STATE OF NEW YORK
DEPARTMENT OF TRANSPORTATION

NOTICE OF HEARING

CASE 40659- Petition of the Long Island Rail Road, pursuant to Section 91 of the Railroad Law, for an order of the Commissioner approving the modifications of an existing crossing (USDOT #338375A) located over the Long Island Rail Road line at Grove Avenue (MP 17.96) in the Village of Cedarhurst, County of Nassau.

**NYS DOT Permanent Design
Approved 01-10-2024**

GROVE AVE
CEDARHURST, NY
DOT# 338375A
SCALE = 1":30'
REVISION 2

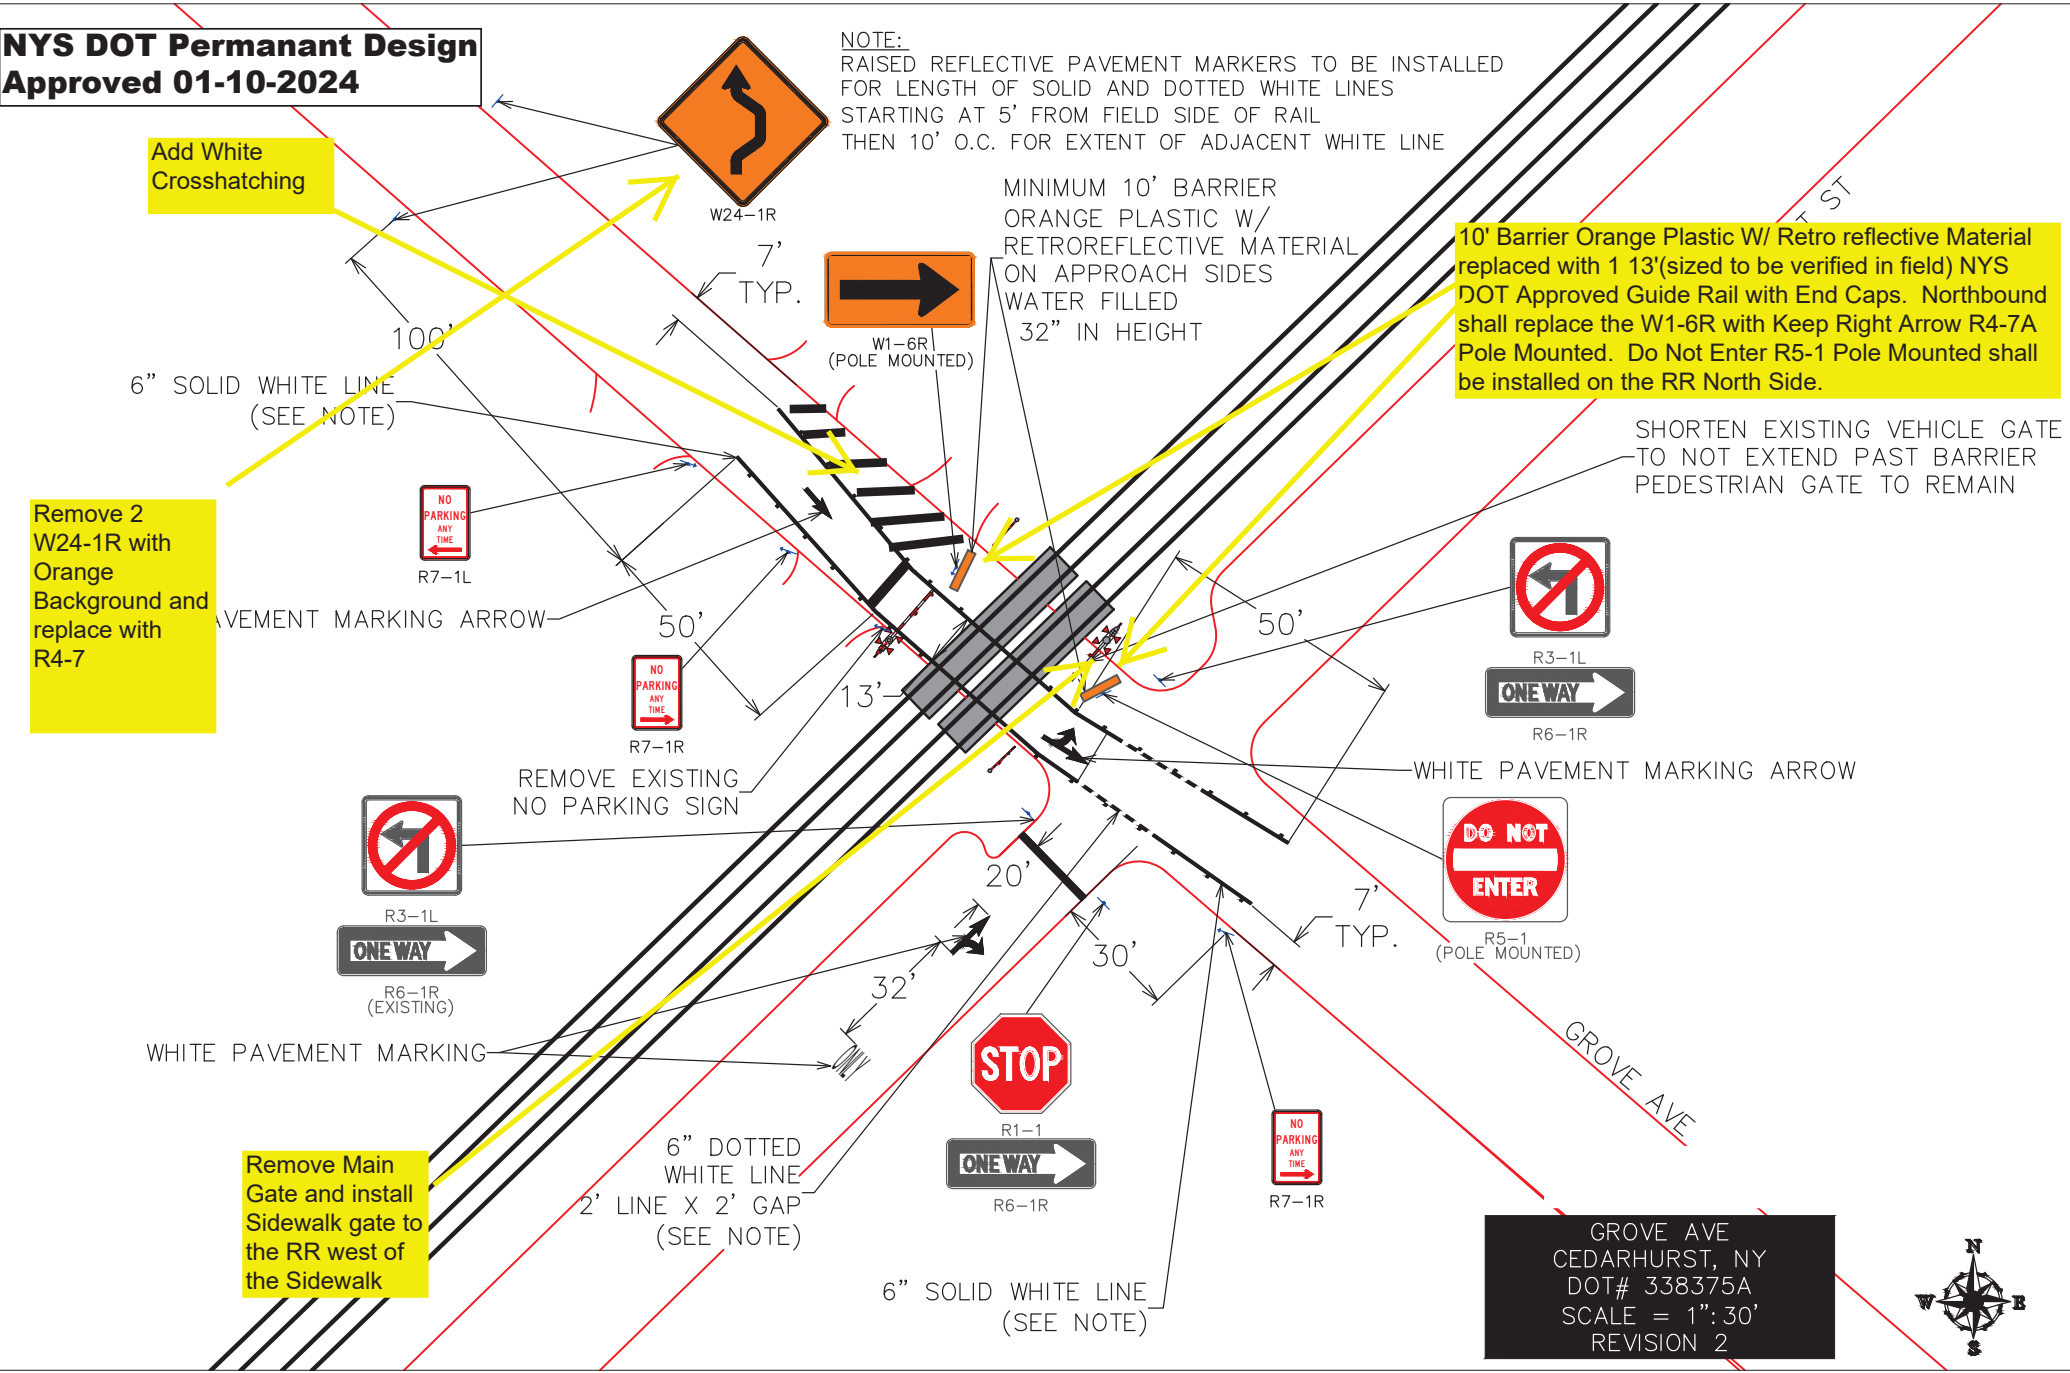
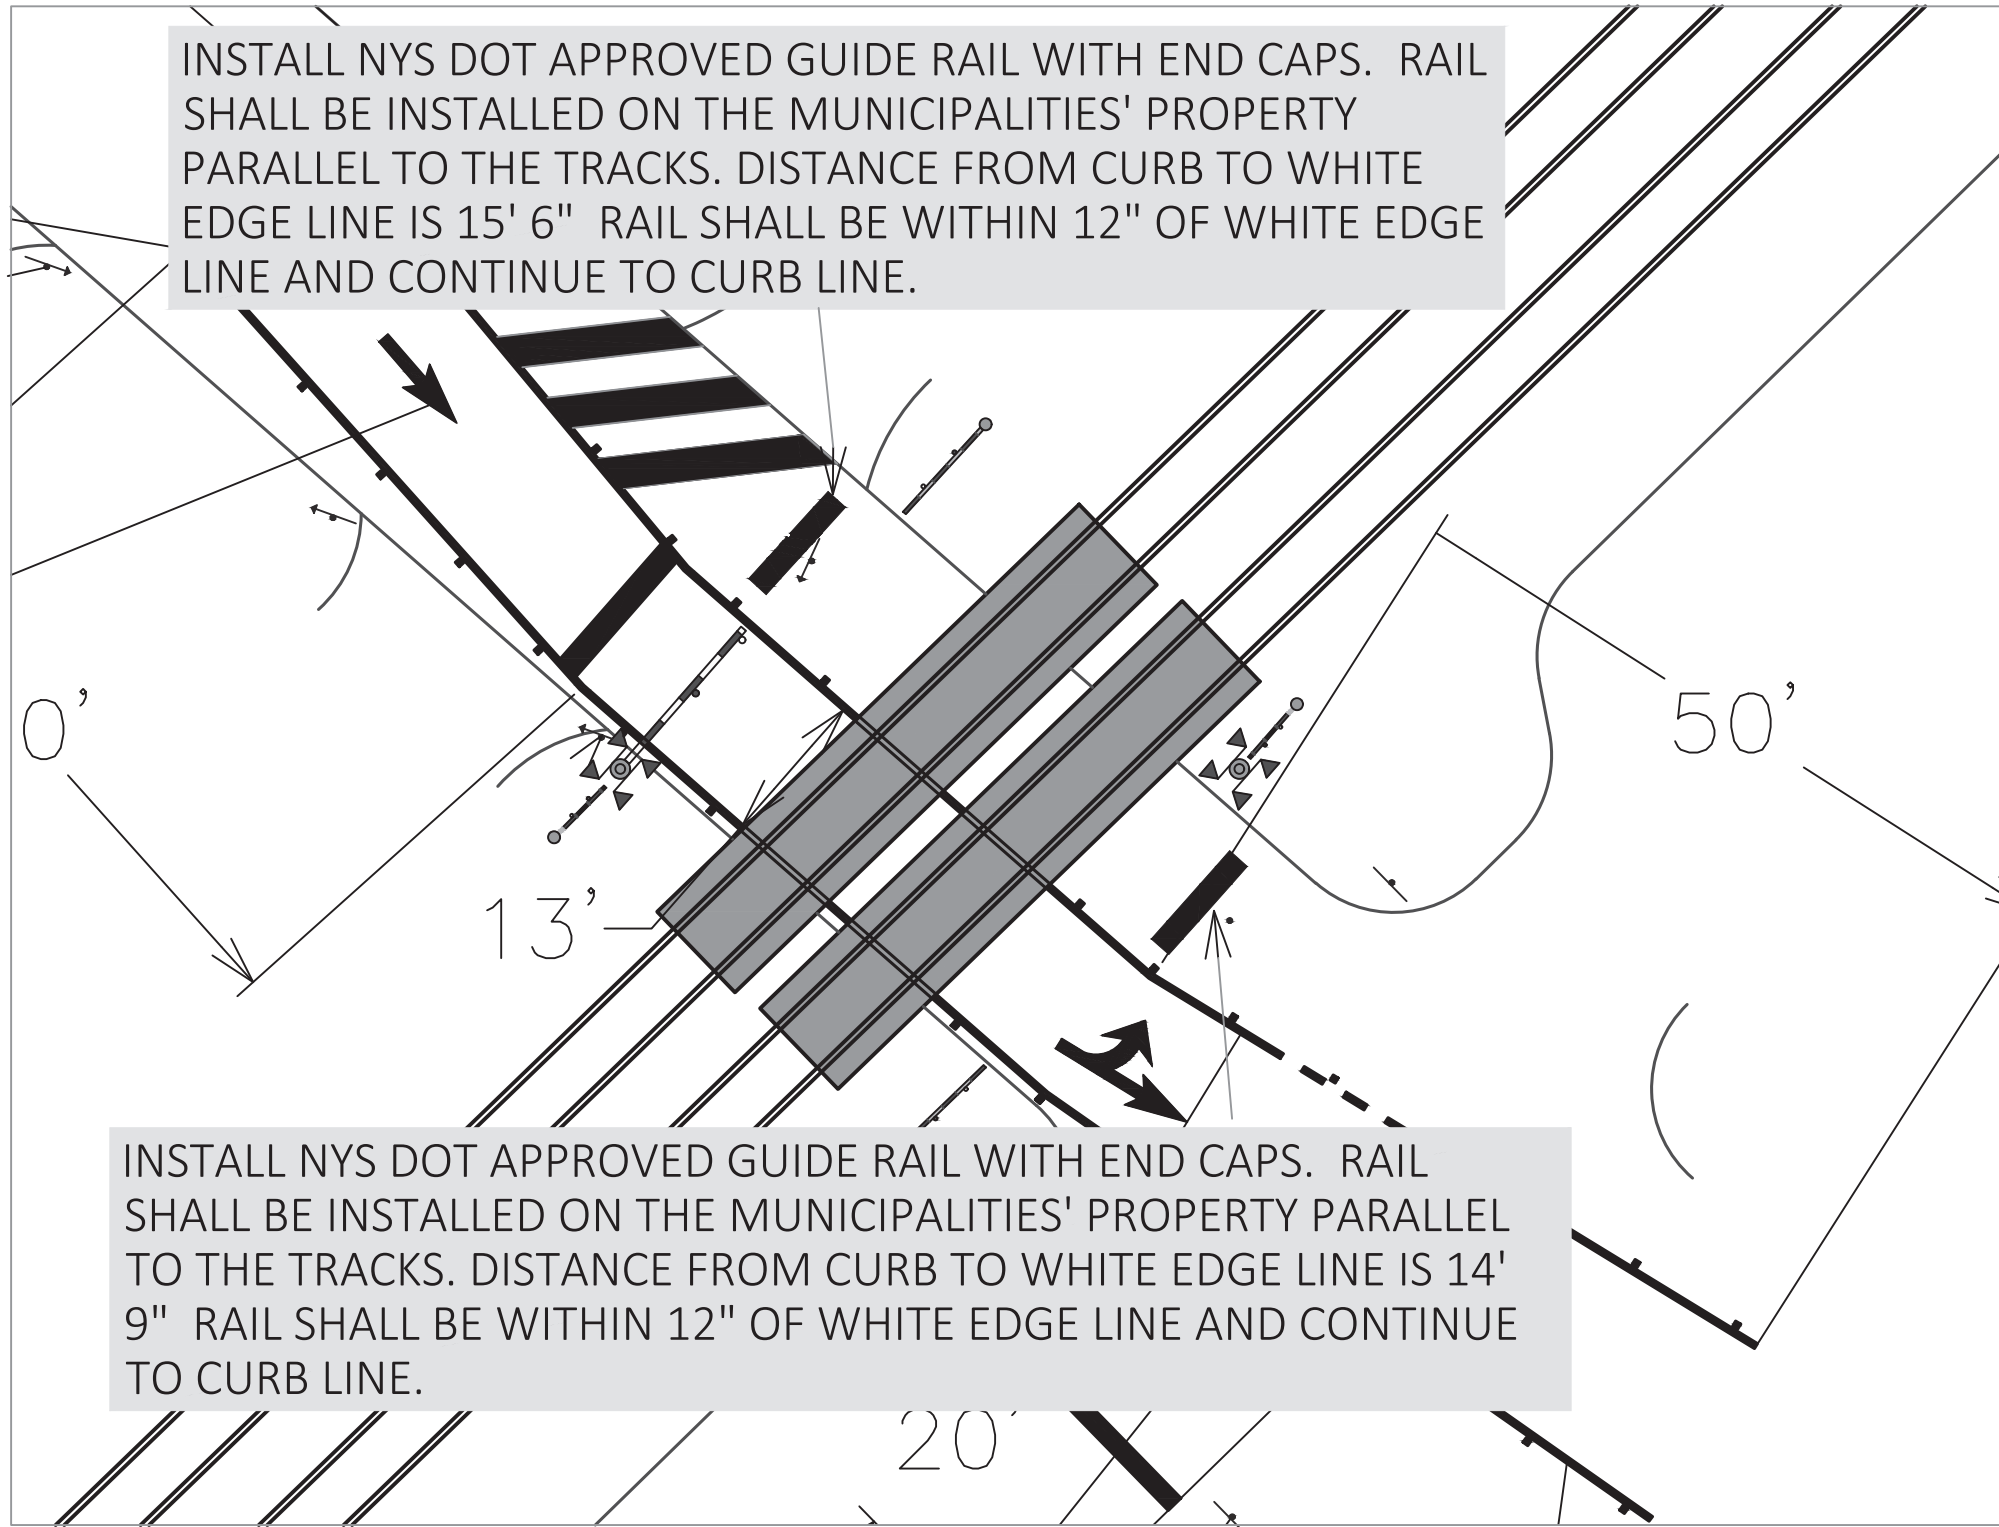
NOTE:
RAISED REFLECTIVE PAVEMENT MARKERS TO BE INSTALLED
FOR LENGTH OF SOLID AND DOTTED WHITE LINES
STARTING AT 5' FROM FIELD SIDE OF RAIL
THEN 10' O.C. FOR EXTENT OF ADJACENT WHITE LINE

Add White
Crosshatching

Remove 2
W24-1R with
Orange
Background and
replace with
R4-7

Remove Main
Gate and install
Sidewalk gate to
the RR west of
the Sidewalk

10' Barrier Orange Plastic W/ Retro reflective Material
replaced with 1 13'(sized to be verified in field) NYS
DOT Approved Guide Rail with End Caps. Northbound
shall replace the W1-6R with Keep Right Arrow R4-7A
Pole Mounted. Do Not Enter R5-1 Pole Mounted shall
be installed on the RR North Side.

SHORTEN EXISTING VEHICLE GATE
TO NOT EXTEND PAST BARRIER
PEDESTRIAN GATE TO REMAIN

10-4-18	11-16-05		METROPOLITAN TRANSPORTATION AUTHORITY	
	8-31-17	8-9-05		THE LONG ISLAND RAIL ROAD	
	04-04-13	9-29-99		F179 SIGNAL LOCATION AT GROVE AVE. CROSSING	FAR ROCK 4-30-82
	01-29-07	6-6-01		F179	1
	10-31-23 REVISED	6-27-07 REVISED		8-23-93 REVISED

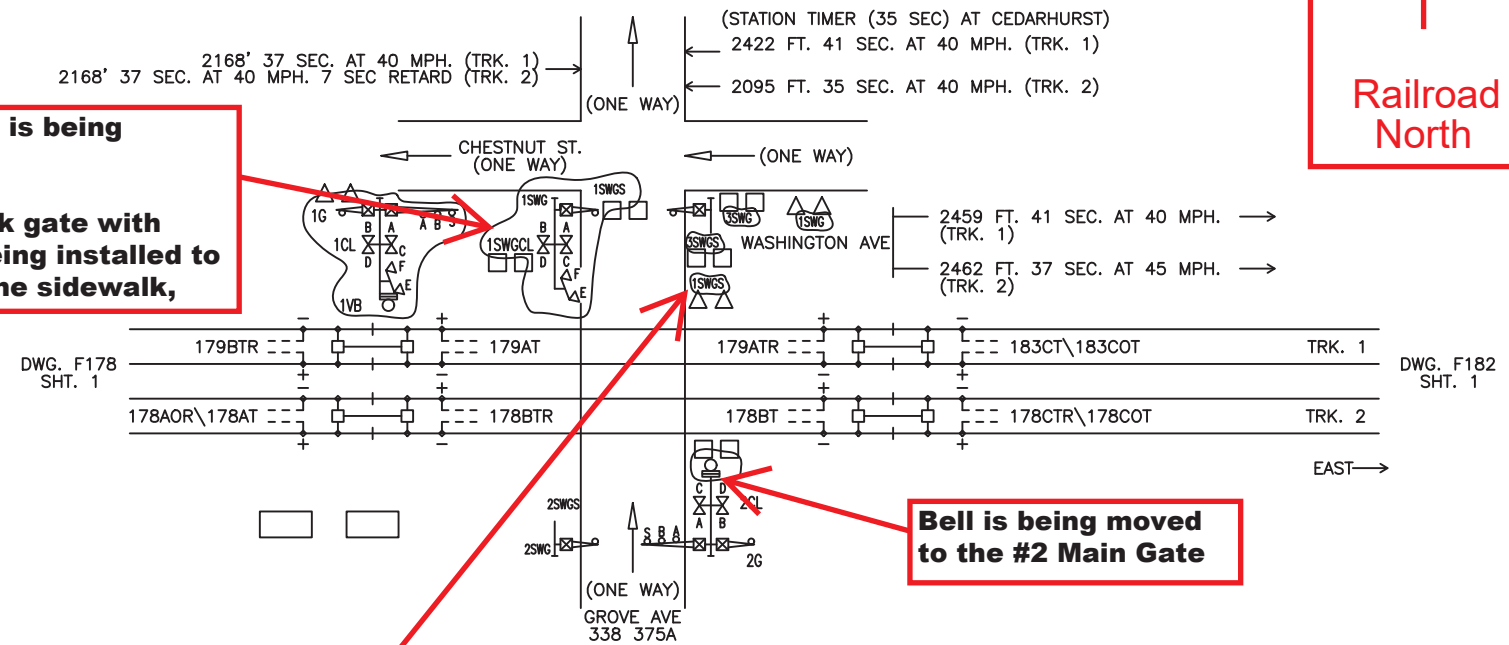
#1 Main Gate is being removed.
A #1 Sidewalk gate with flashers is being installed to the west of the sidewalk,

The current #1 Sidewalk gate is being renamed to #3 sidewalk gate. the position of this gate is not changing.

Bell is being moved to the #2 Main Gate
